VILLAGE OF LOMBARD
REQUEST FOR BOARD OF TRUSTEES ACTION
For Inclusion on Board Agenda

TITLE: PC 14-02; Text Amendments to the Zoning Ordinance – Parking Dimensions

Subject: PC 14-02; Text Amendments to the Zoning Ordinance – Parking Dimensions

PC 14-02

Figure 6-1

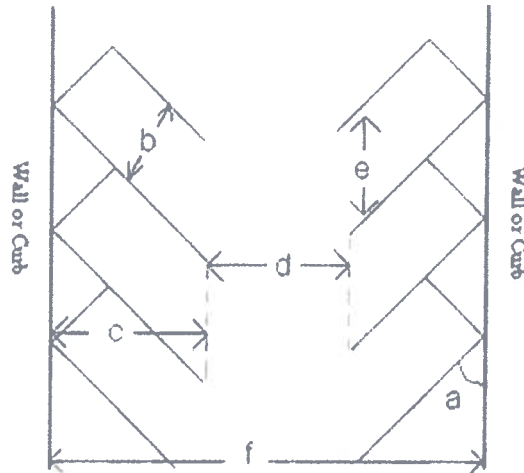
The Fire Department response to staff's initial proposed dimensions expressed a concern regarding insufficient drive aisle width to accommodate safe navigation and setup of Fire Department apparatus.

Private Engineering Services provided the following comments in response to staff's initial proposed dimensions:

1. The aisle widths are really narrow as shown.

- a. 1990 ITE standards show that one-way forty-five degree (45°) parking should have a minimum fifteen foot (15') wide drive aisle, one-way sixty degree (60°) parking should have a minimum eighteen foot (18') wide drive aisle, and ninety degree (90°) parking should have a twenty-six foot (26') wide drive aisle. It is PES' opinion that the proposed drive aisles are too narrow.
 - b. If a vehicle breaks down, there is no available width for another vehicle to pass. PES proposes the existing aisle width standards be left as are. This could also be an issue for the fire department in regards to a possible vehicle fire and needing to get a fire truck through the aisles.
2. If using a two-way drive aisle, the sixty degree (60°) dimensions should be as the same as for two-way ninety degree (90°) parking.

The proposed text amendments were then revised by staff to address the Fire Departments concerns. The proposed drive aisle for sixty degree (60°) and forty-five degree (45°) parking is now two feet (2') wider than the Fire Department's minimum request.

Planning staff addressed all of PES' comments and concerns in the revised text amendments that are currently proposed.
